# TECHNICAL INFORMATION

**Subject** ▶ Change of Spur gear 51 and Driving flange  
Elimination of Pin 6 and Flat washer 30

**For Models** ▶ BHR242, BHR243, DHR242, DHR243, HR2300, HR2310T, HR2600, HR2601, HR2610, HR2610T, HR2611F, HR2611FT, HR2621, LXRH01, LXRH02, XRH01, XRH02

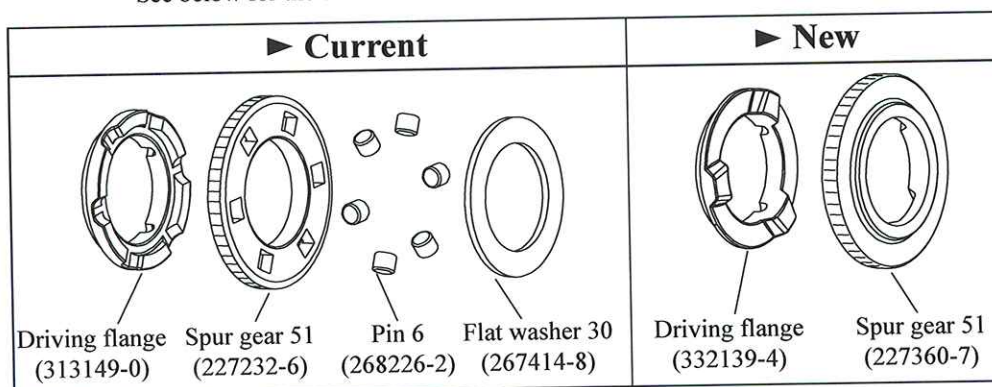
**Description** ▶ To improve the durability of Spur gear 51:  
• Spur gear 51 and Driving flange have been changed.  
• Pin 6 (6 pcs.) and Flat washer 30 have been eliminated.  
See below for the details.

Item No.	Current part		Q'ty	I/C	New part		Q'ty	Note
①	See below.	Spur gear 51 227232-6		1	No	Spur gear 51 227360-7		1	Interchangeable as a set
②		Driving flange 313149-0		1	No	Driving flange 332139-4		1	
③		Flat washer 30 267414-8		1					
④		Pin 6 268226-2		6
